**CALIFORNIA REGIONAL WATER QUALITY CONTROL BOARD  
CENTRAL VALLEY REGION**

**CEASE AND DESIST NO. R5-2014-XXXX**

**RECOLOGY HAY ROAD  
JEPSON PRAIRIE ORGANICS AS A DBA OF RECOLOGY HAY ROAD  
RECOLOGY HAY ROAD LANDFILL  
SOLONO COUNTY**

**PROSECUTION TEAM'S REBUTTAL ARGUMENT – LEGAL AND TECHNICAL ANALYSIS  
CEASE AND DESIST ORDER NO. R5-2014-XXXX**

### Lowest Point at DM-3.3: bottom of the unit versus location of the LCRS

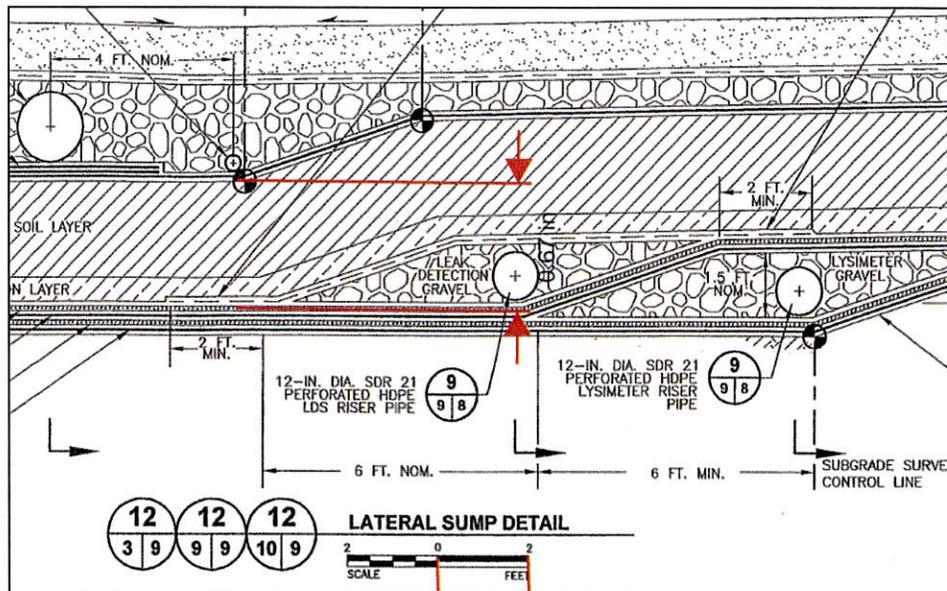
As described above, the Discharger is required to measure the separation to groundwater from the lowest point of each disposal unit, which is also the lowest point at which leachate may be present. The design drawings and Construction Quality Assurance (CQA) reports for the various landfill units contain the surveyed bottom elevation of each unit. Staff has reviewed these documents. For units DM-2.2, 5.1, 9, and 11, it appears that the Discharger is measuring the separation from the bottom of the LCRS, which is the correct location.

However, for units DM-3.1, 3.2, 3.3, 4.1, 5.2 and 6, it appears that the Discharger is measuring from the lowest point of the primary liner system (i.e., the LCRS sump). This is not appropriate, as the lowest point of the unit at which there could be leachate is the secondary liner, which is the elevation of the leak detection sump. For example, at Unit DM-3.3, the Discharger calculates the separation from a point located two feet eight inches (2'8") higher than the lowest point of the unit<sup>1</sup>, as shown in the diagram below. The proposed CDO will be revised to require the Discharger to use the lowest elevation at which leachate could collect (i.e., either the LCRS sump or the bottom of the secondary liner, depending on how the particular unit was constructed) as the point from which the Discharger must measure the separation to groundwater.

<sup>1</sup> For DM-3.3 the compacted subgrade is the lowest point of the containment system. However, the start of the liner system (i.e., the secondary liner) overlays the subgrade. For practical purposes, the lowest point of DM-3.3 is bottom of the secondary liner, which is the elevation of the leak detection system (and the pan lysimeter). For DM-3.3, the surveyed elevation at the lowest point of the unit is provided in the construction report, and these measured values are stamped and signed by a licensed land surveyor.
